Regulation No. 43 (Safety glazing)

Proposal for draft 01 series of amendments to Regulation No. 43

Submitted by the expert from the European Association of Automobile Suppliers*

Glass-plastic panes other than windscreens

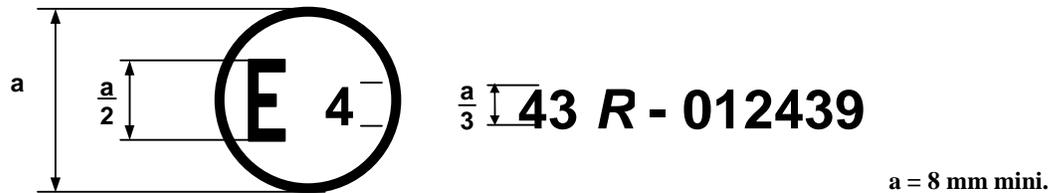
The above approval mark affixed to glass-plastic pane other than a windscreen, shows that the component concerned has been approved in the Netherlands (E 4) pursuant to Regulation No. 43 under approval No. 012439. The approval number indicates that the approval was granted in accordance with the requirements of Regulation No. 43, as amended by the 01 series of amendments”

Support for ball tests

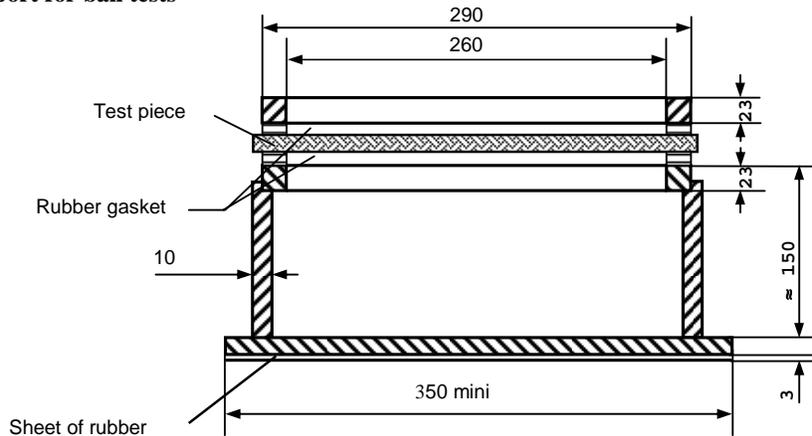
Paragraph 2.1.1.3, figure 1, amend to read:

Figure 20: Sample

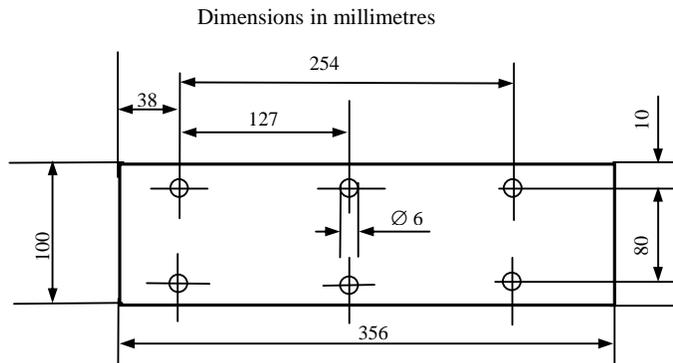
Paragraph 10.5.1., figure 20, amend to read:

Prescribed points of impact for uniformly toughened glass panes

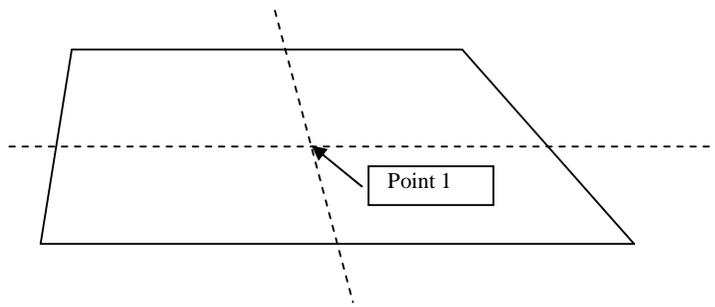
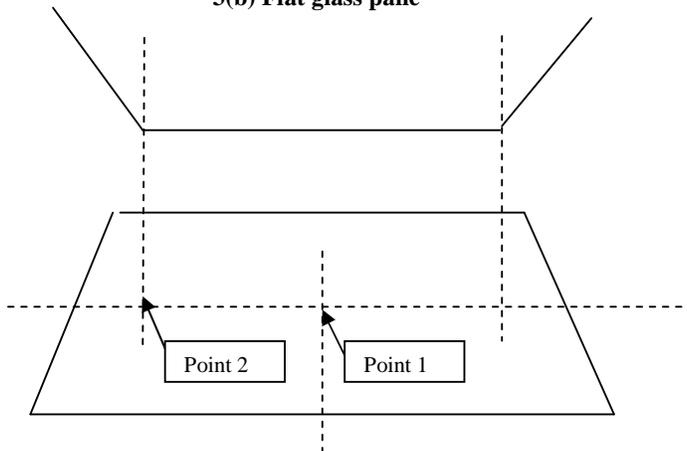
Annex 17, figure 3, amend to read:
